INDIANA DEPARTMENT OF TRANSPORTATION

APPROVED MINUTES

August 18, 2016 Standards Committee Meeting

RE: Minutes from the August 18, 2016 Standards Committee Meeting

STANDARD DRAWING E 720-ICCA-19 CASTING TYPE 15 (ALTERNATE) FRAME, GRATE, AND CURB BOX

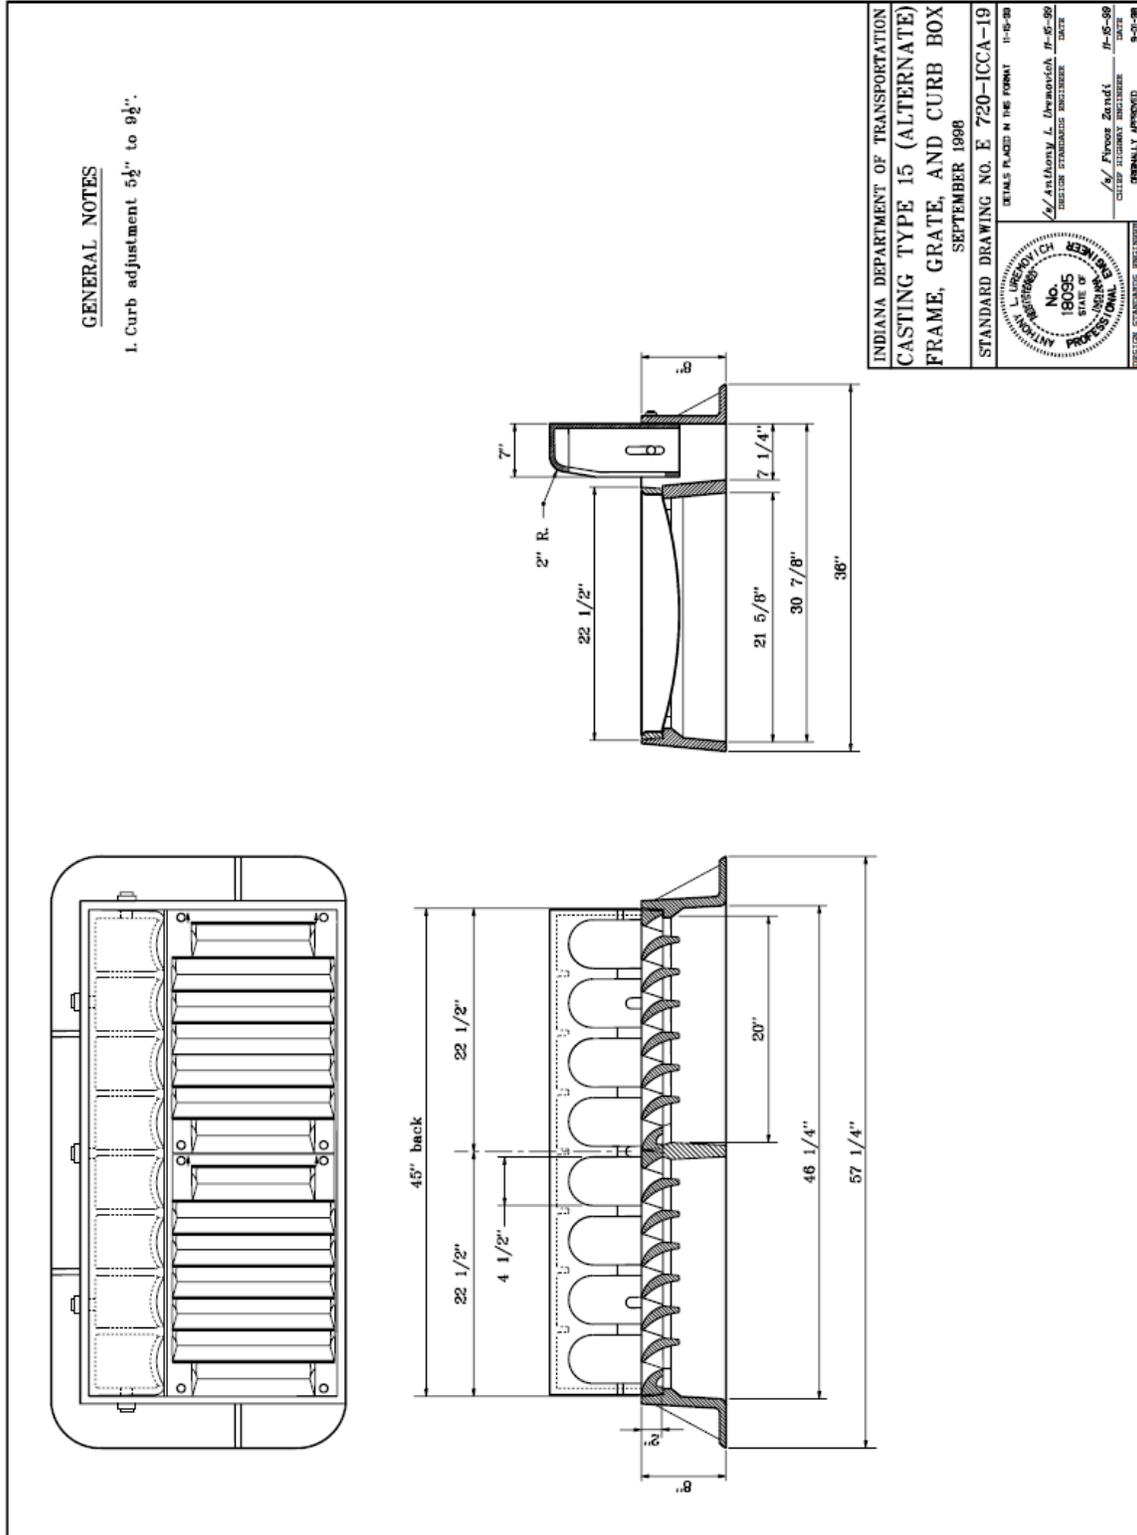
PROBLEM(S) ENCOUNTERED: Several requests from industry to allow the use of a monolithic Type 15 inlet curb casting in lieu of a separate frame and curb box.

PROPOSED SOLUTION: Immediate solution: Create brief RSP to allow use of a monolithic casting where 6" curb height is specified.
Longterm solution: Add note to Standard Drawings that allows use of monolithic casting where 6" curb height is specified.

A monolithic casting can be a more cost-effective, but is set at a fixed 6" curb height.

Ms. Phillips asked that the word "grate" be struck from the RSP since it is not included in the monolithic casting.

Where a 6 in. curb height is specified, a monolithic frame and curb box may be used in place of one with modular components, provided the monolithic casting's dimensions match those shown on the plans.

805-SGCO-01 SIGNAL SERVICE & CONTROLLER MOUNTED ON WOOD POLE (WITH MARKUPS)

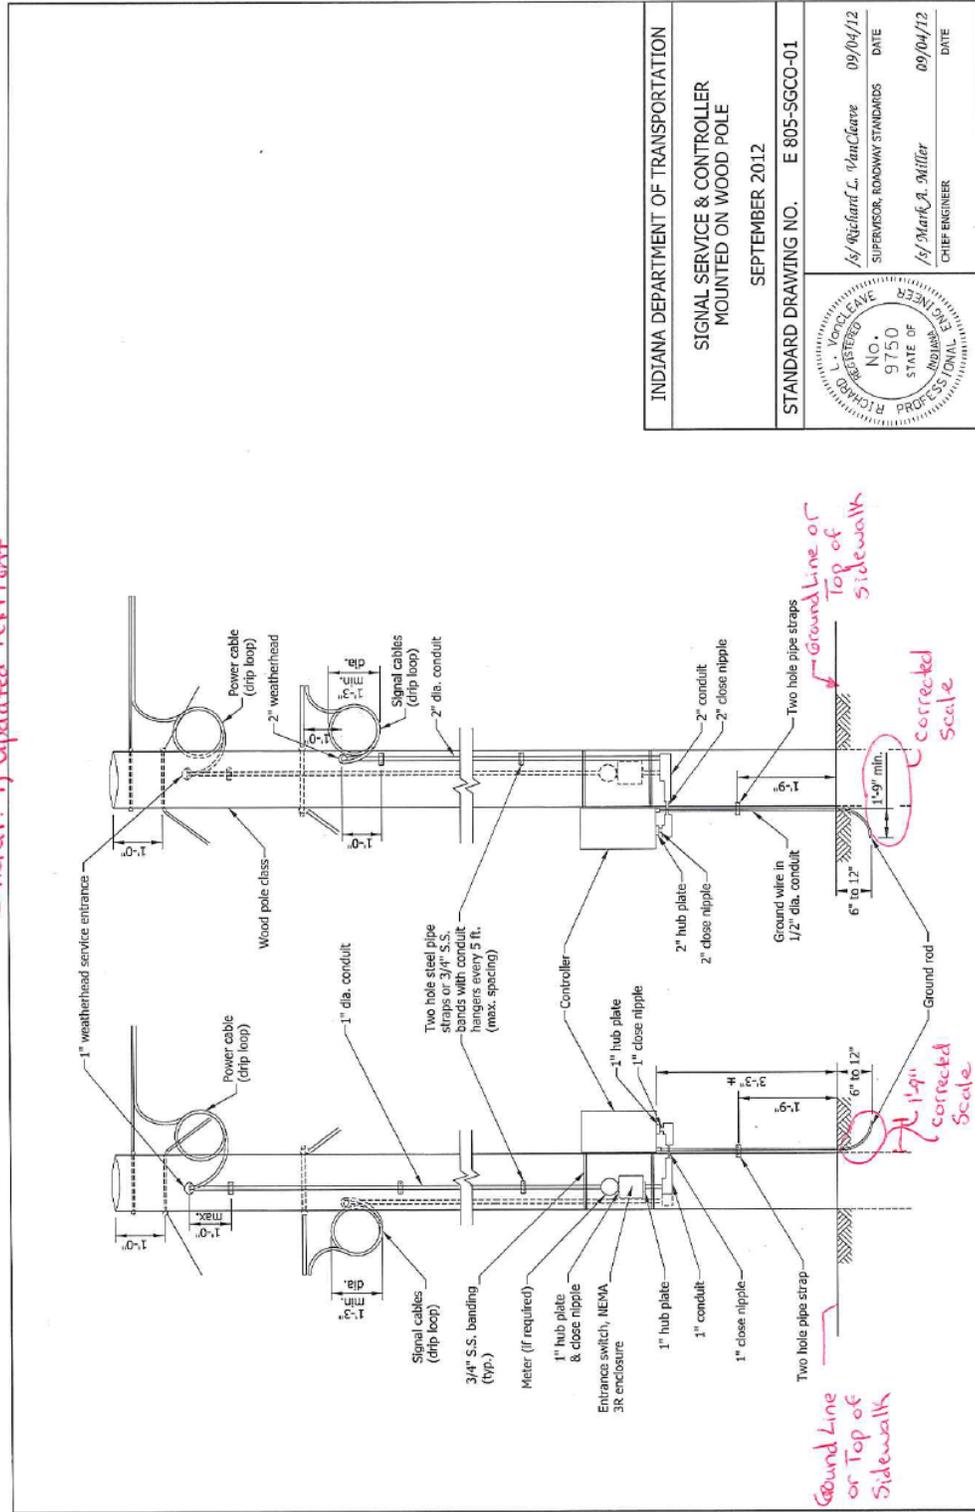
General: 1) updated Text Font

corrected Scale

805-SGCO-02 SIGNAL SERVICE & CONTROLLER MOUNTED ON STEEL POLE (WITH MARKUPS)

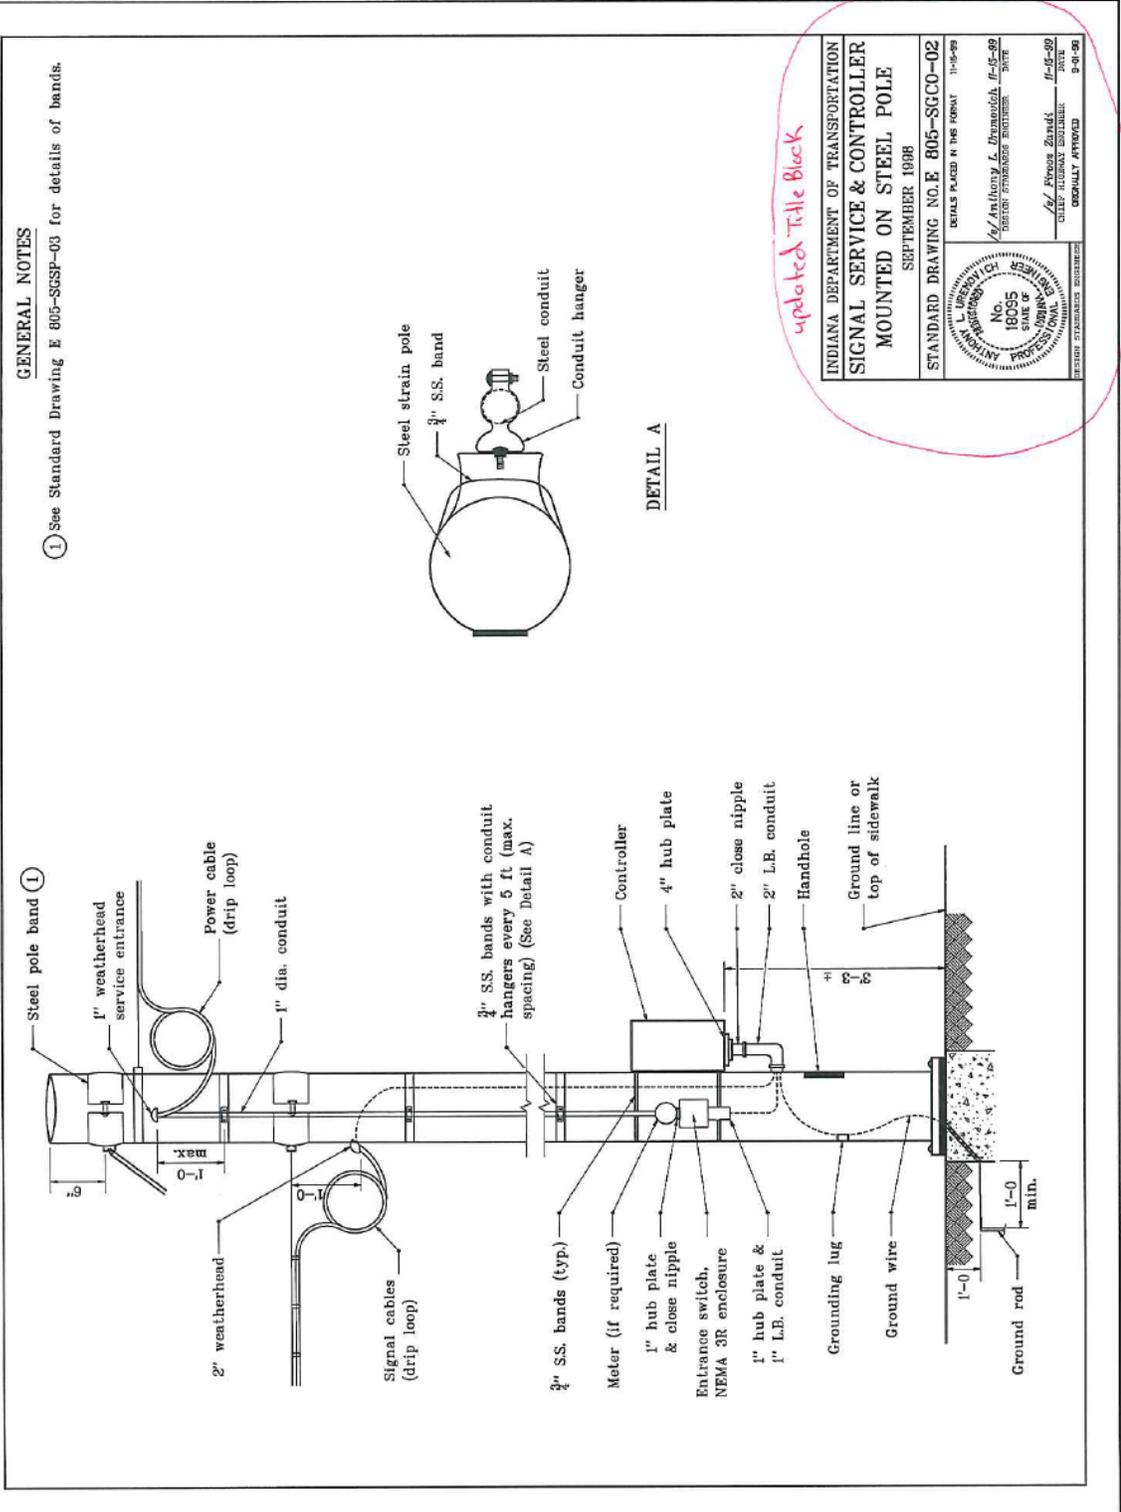
General: 1) Updated Text Font
2) updated Drawing Scale

805-SGCO-03 SIGNAL SERVICE ON WOOD POLE (WITH MARKUPS)

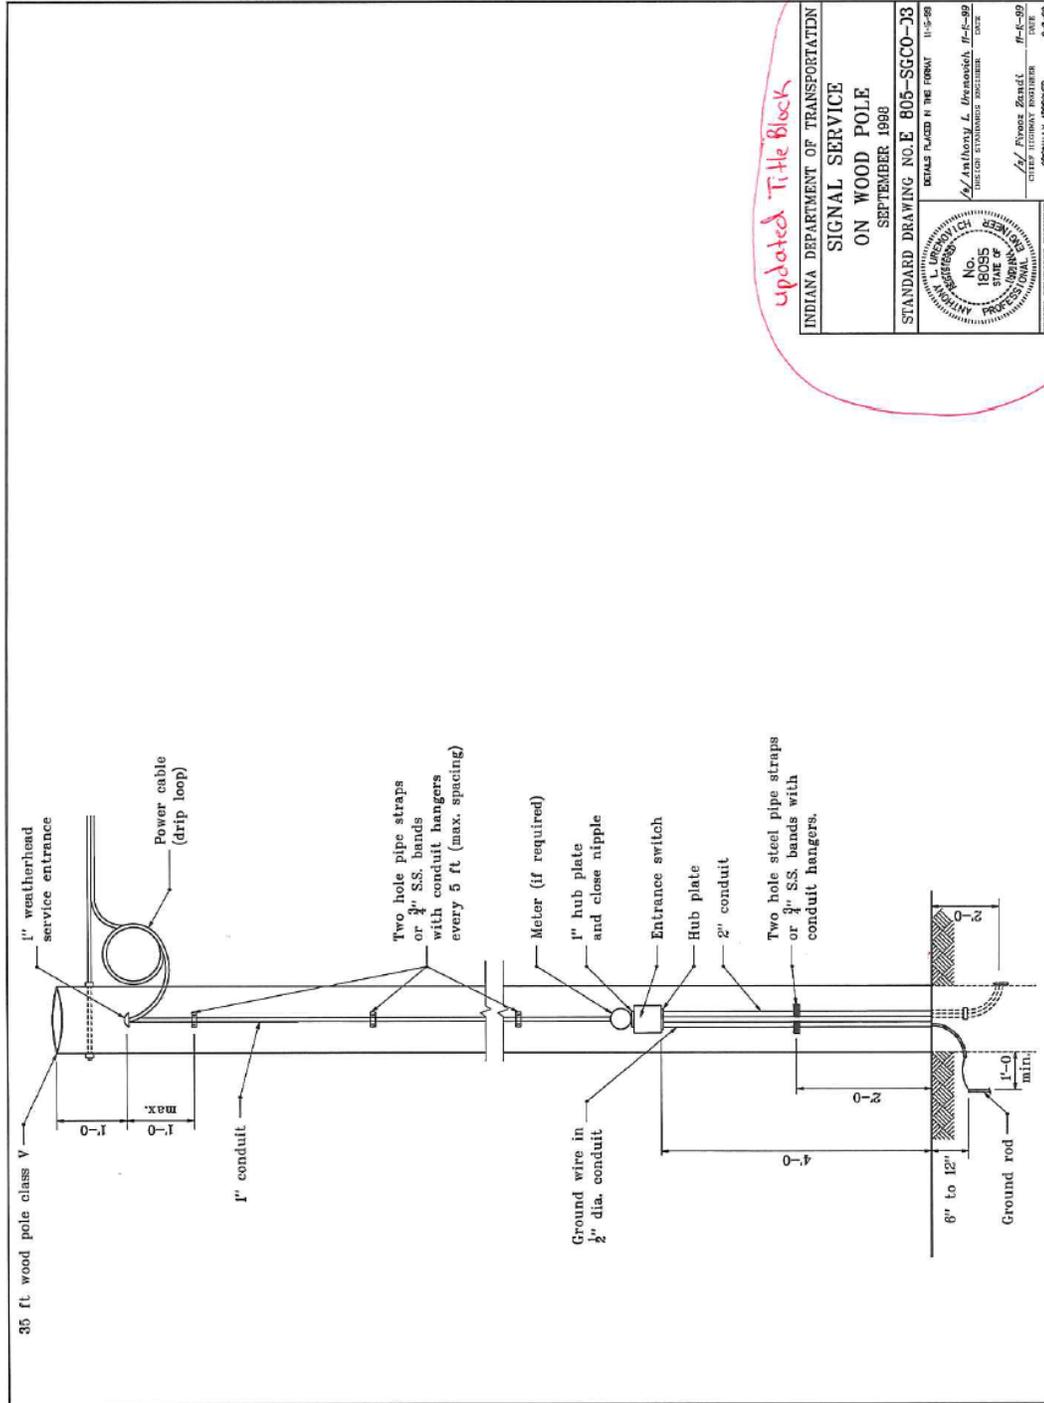
General: 1) Updated Text Font
2) updated Drawing Scale

updated Title Block

805-SGCO-04A SIGNAL INDICATION MOUNTED ON STEEL POLE (WITH MARKUPS)

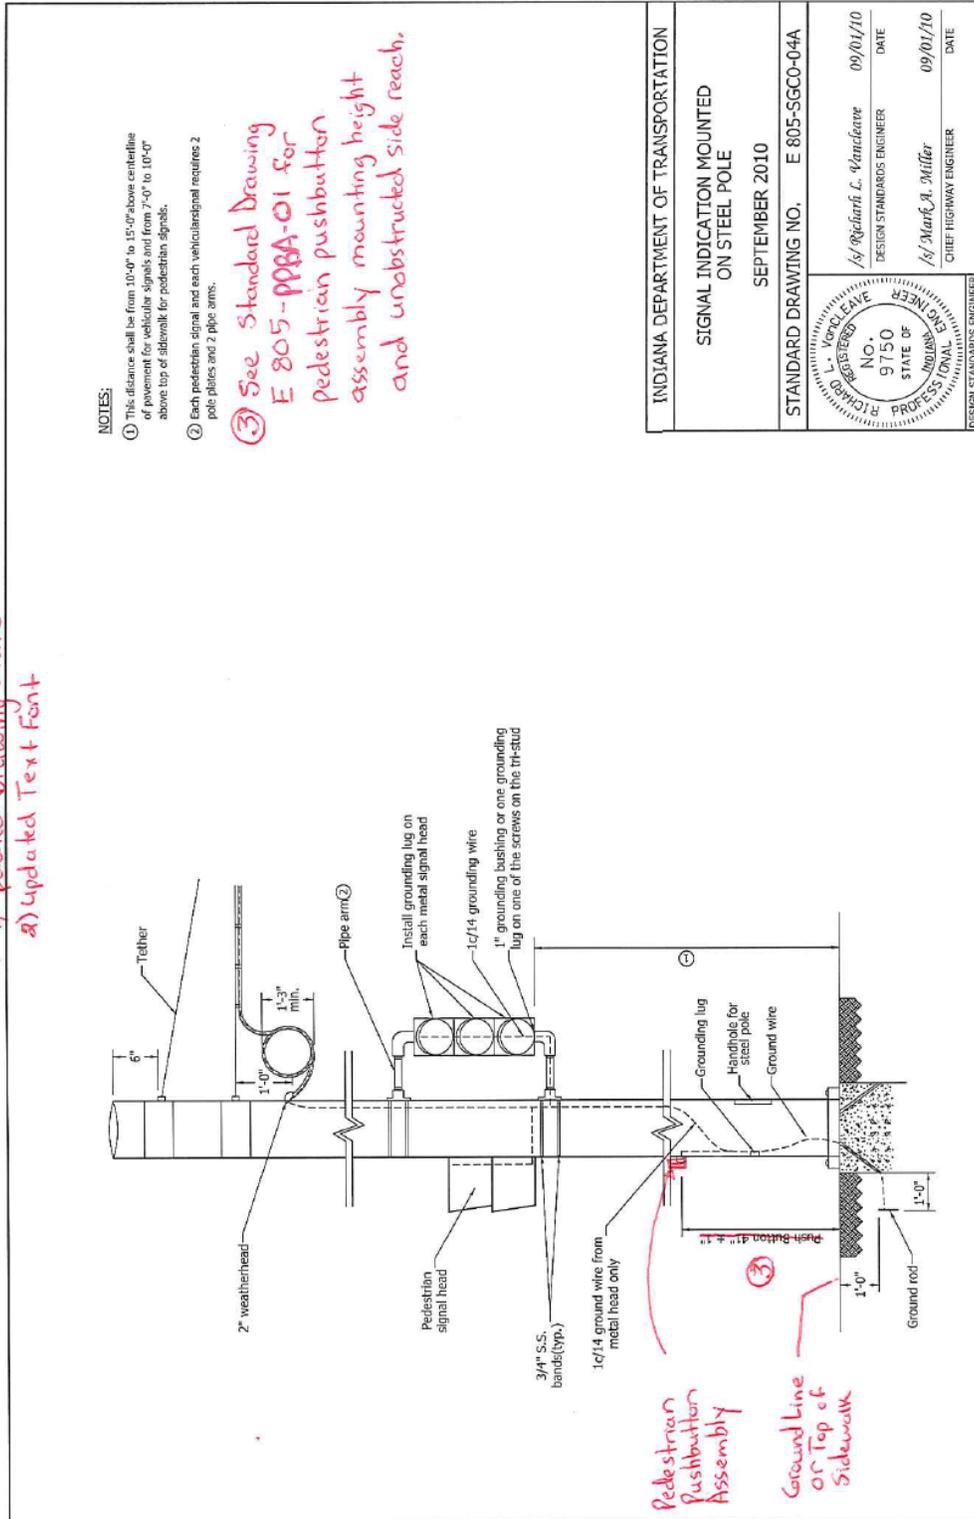
General - updated Drawing Scale
a) updated Text Font

805-SGCO-04B SIGNAL INDICATION MOUNTED ON WOOD POLE (WITH MARKUPS)

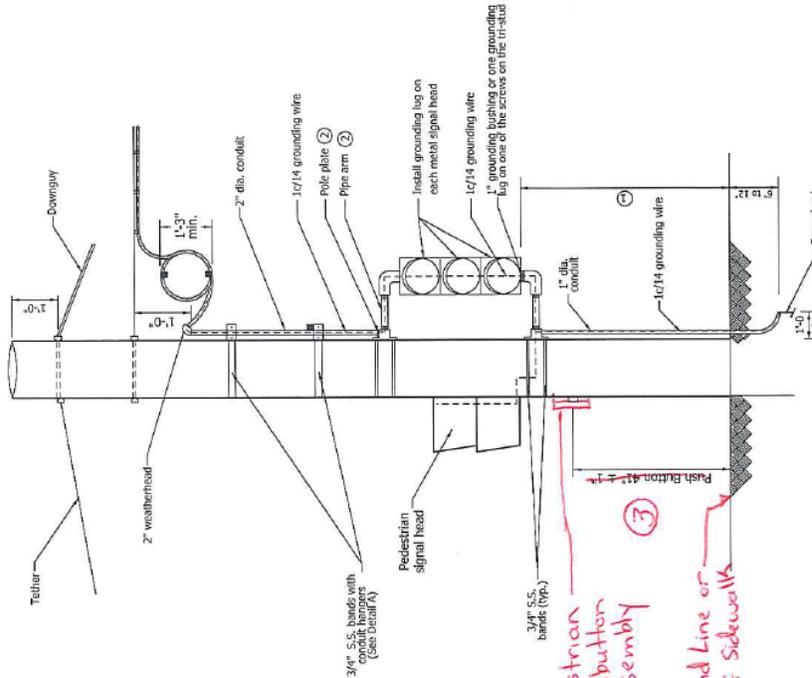
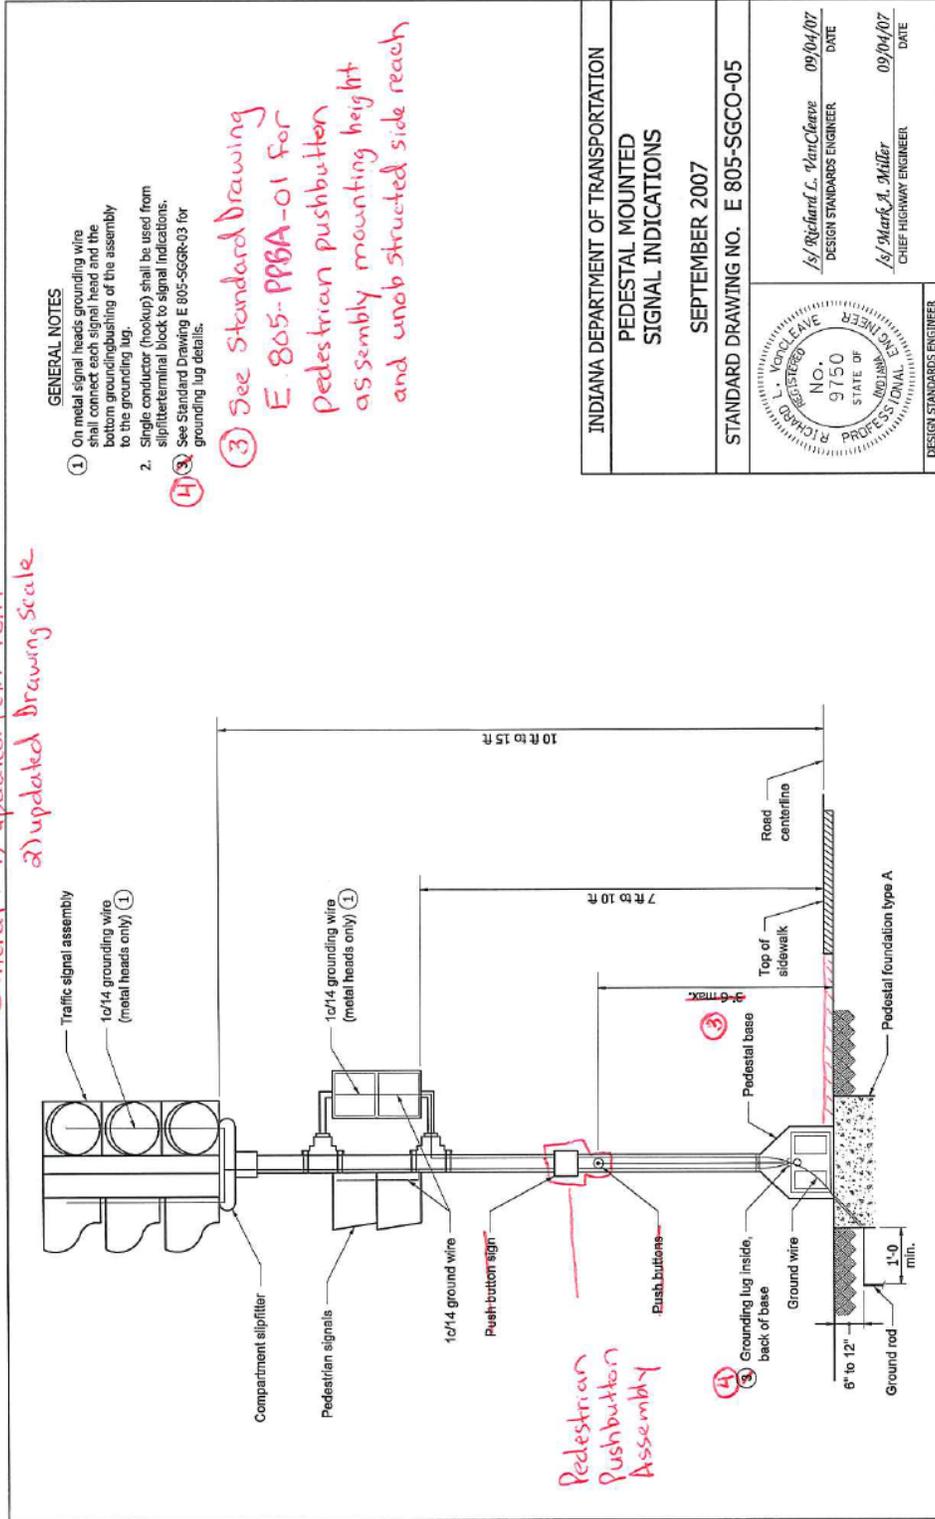
General: 1) updated Drawing Scale
2) updated Text Font
